PRELIMINARY/ FINAL DRAINAGE REPORT FOR RIVERBEND CROSSING FILINGS NO. 1 AND 2

SEPTEMBER 2018

PCD FILE NOS:
SP 187
SF 1843
SF 1844

RIVERBEND CROSSING
PROPOSED DRAINAGE PLAN

Project: Riverbend Crossing
 Inlet ID: B14

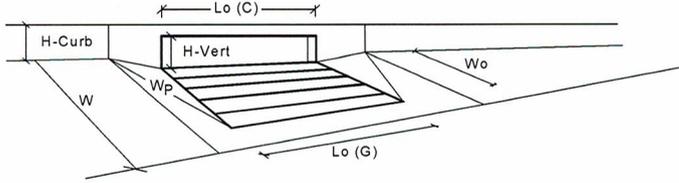
Revise longitudinal slope. Inlet is at grade.

Revise inlet calc. Construction plans show this as an at-grade inlet.

Revised to At Grade

REVISED TO 0.67 SLOPE

B15

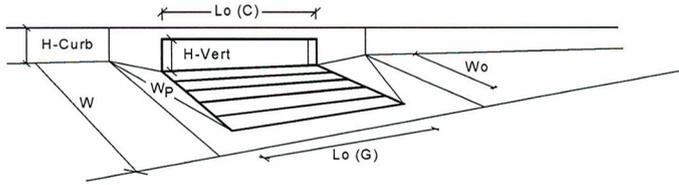
Revise. P&P shows 1% slope towards the inlet.

Revise inlet calc. Construction plans show this as an at-grade inlet.

Revise inlet calc. Construction plans show this as an at-grade inlet.

Revised Slope

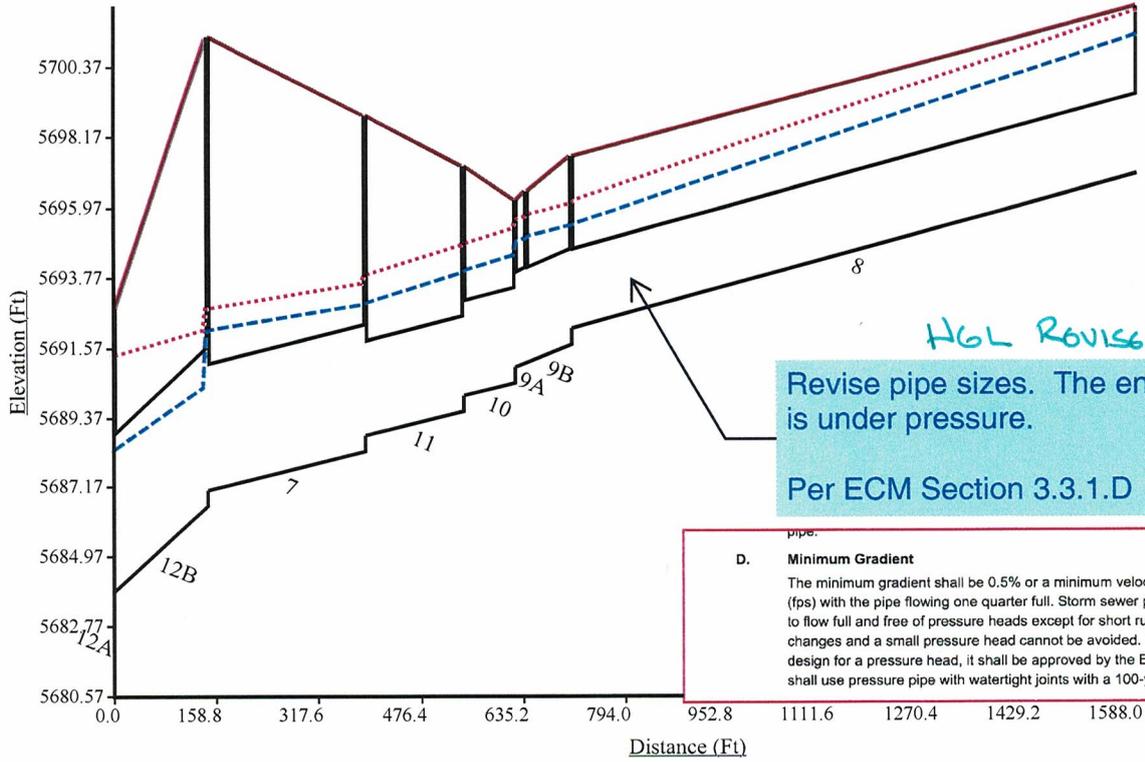
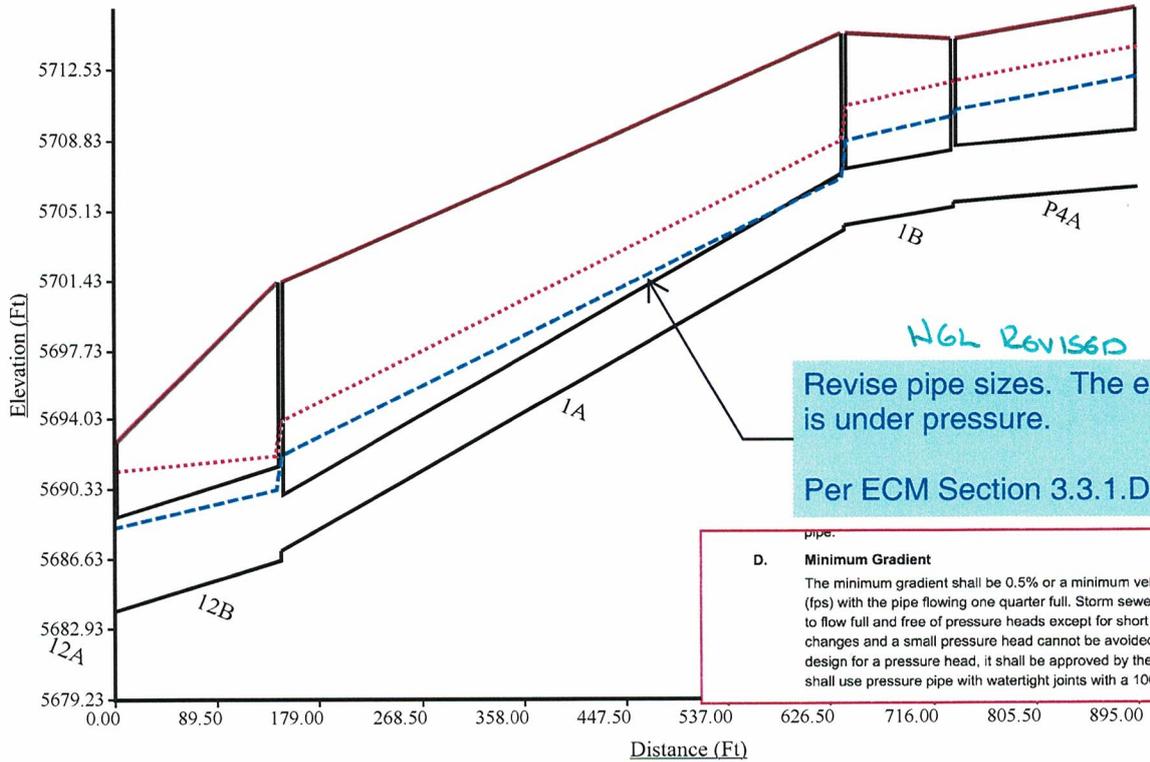
Adjust. Max velocity is 18fps

HGL Revised

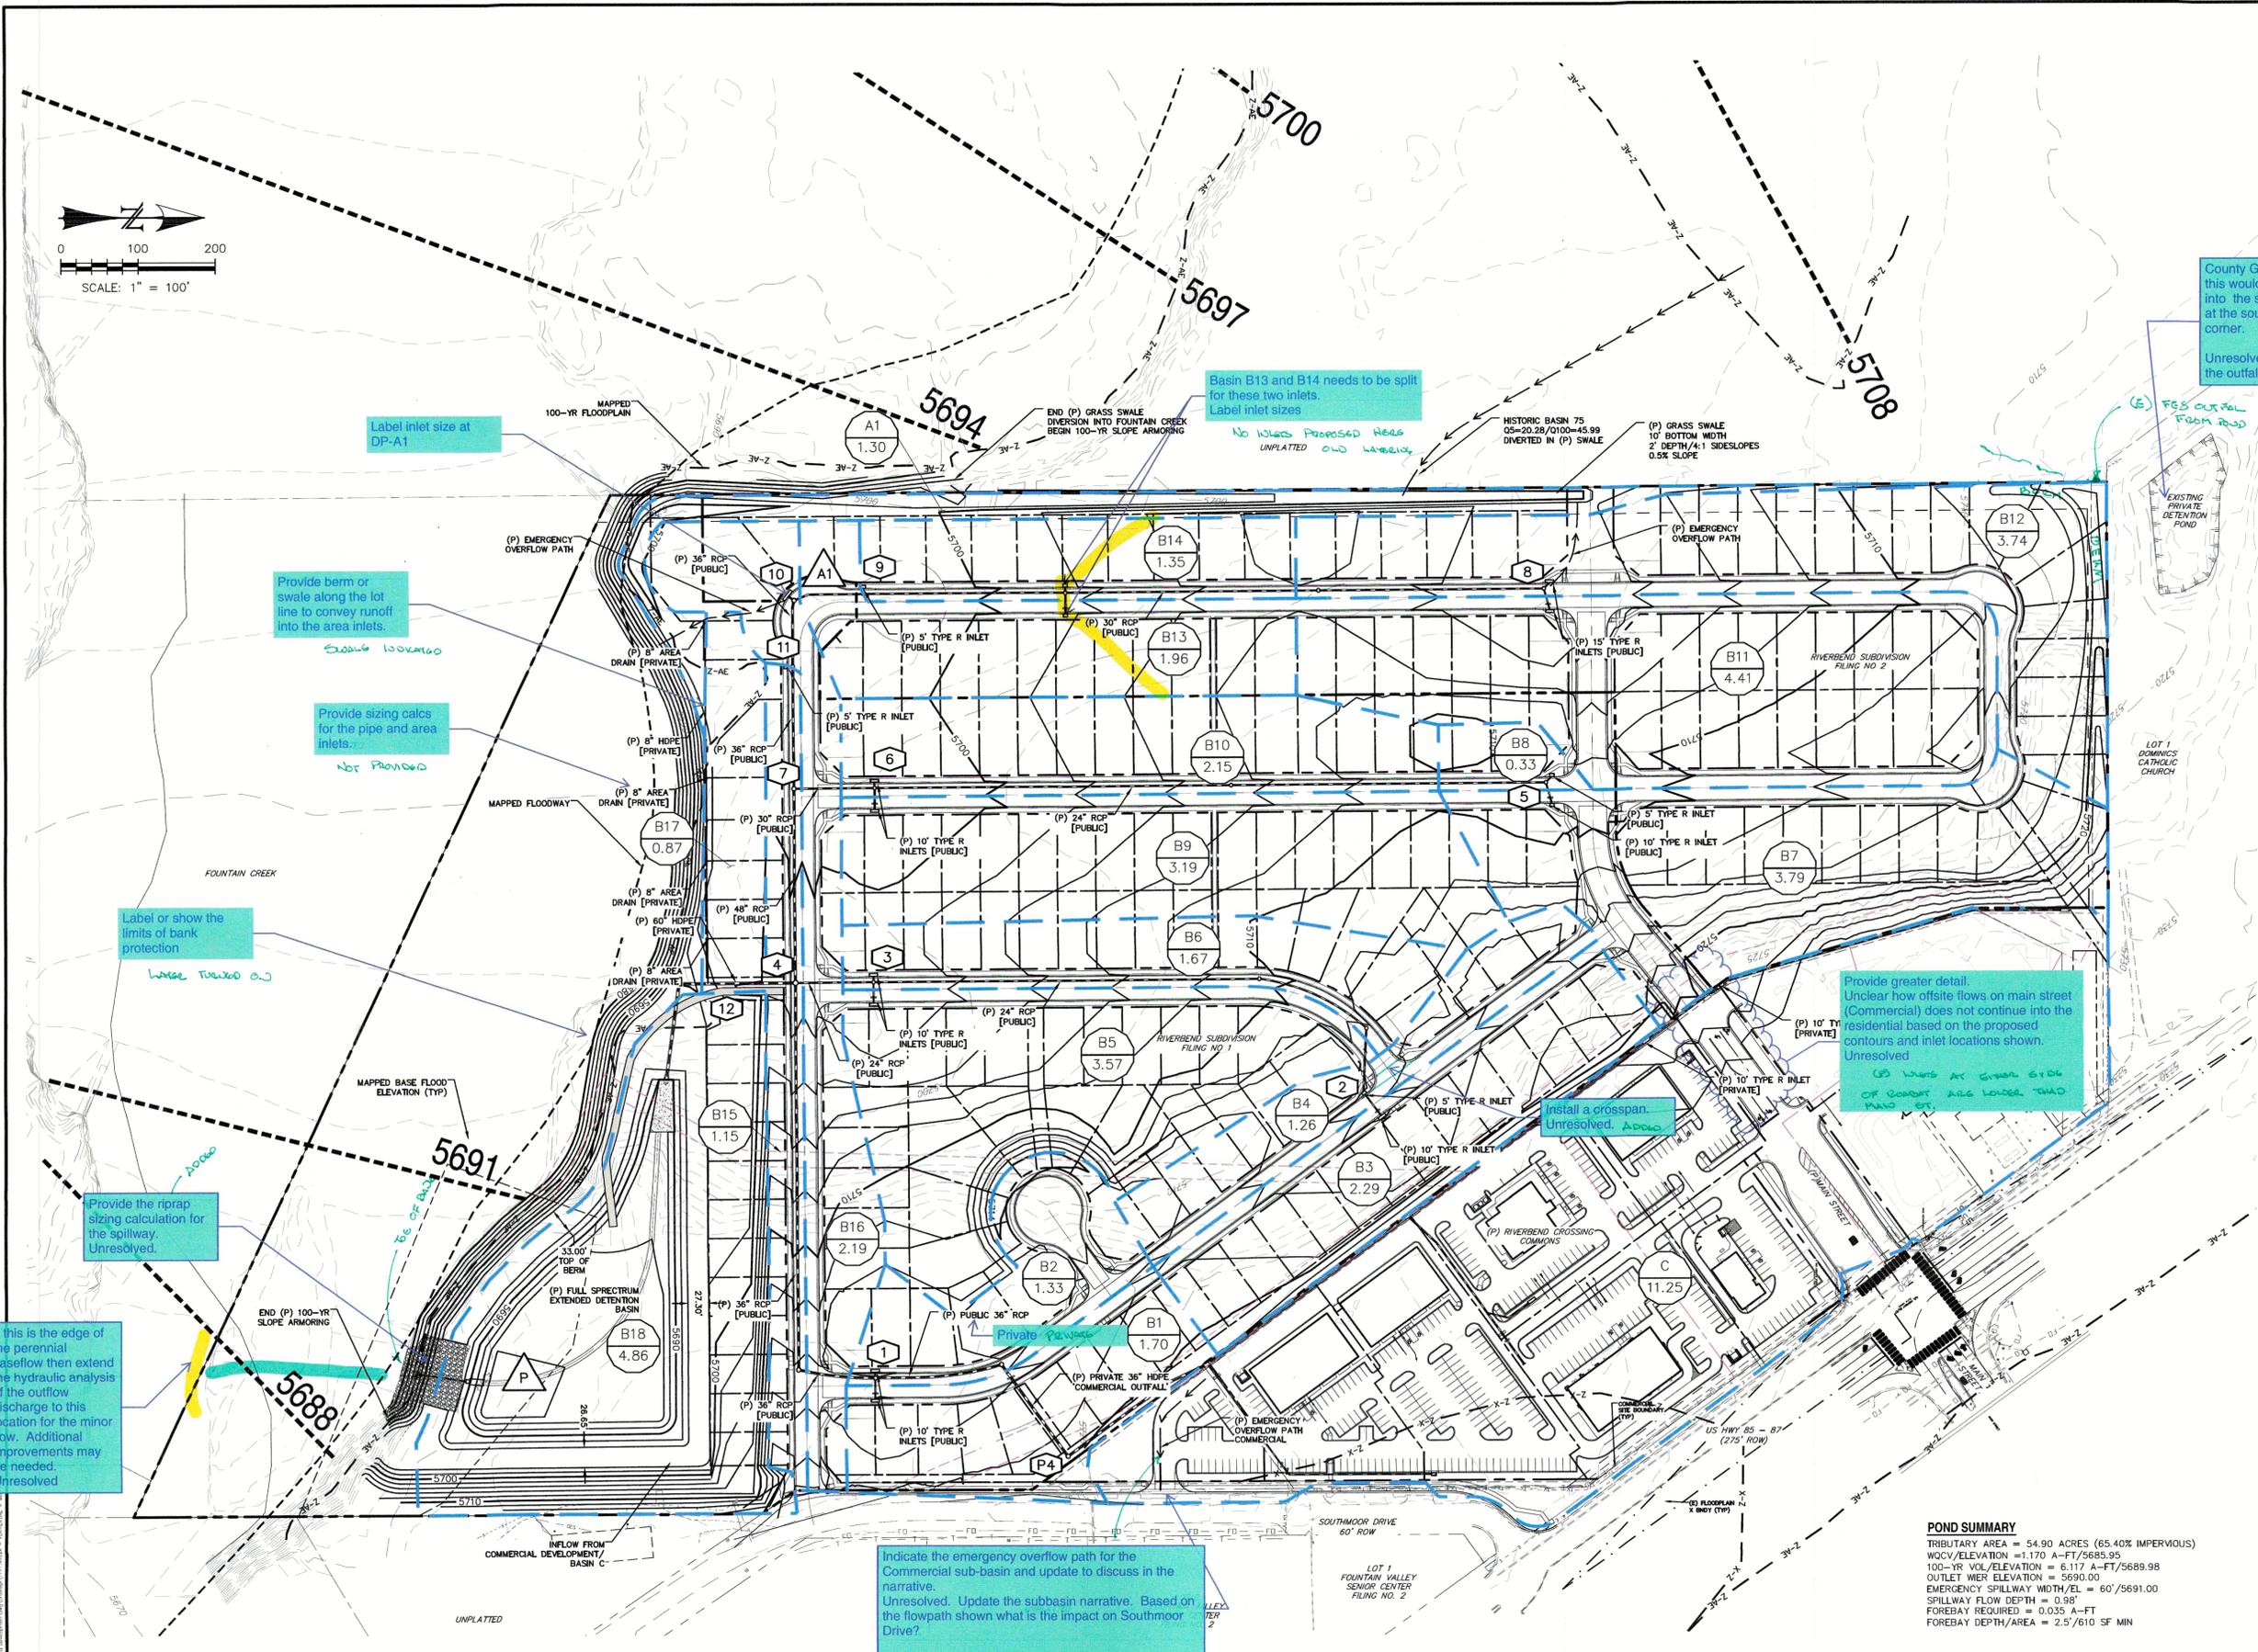
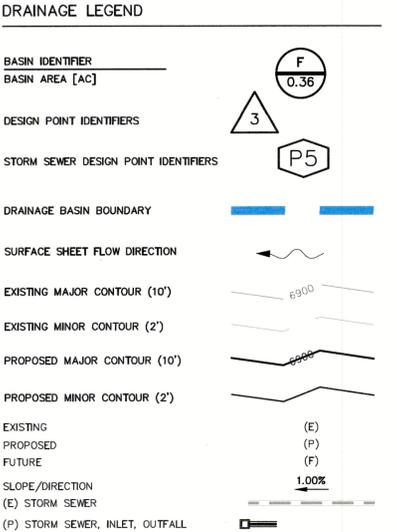
County GIS shows this would drain back into the subdivision at the southwest corner.
Unresolved. Show the outfall location.

Label inlet size at DP-A1

Provide berm or swale along the lot line to convey runoff into the area inlets.

Provide sizing calcs for the pipe and area inlets.

Label or show the limits of bank protection

Provide the riprap sizing calculation for the spillway.

Provide greater detail. Unclear how offsite flows on main street (Commercial) does not continue into the residential based on the proposed contours and inlet locations shown.
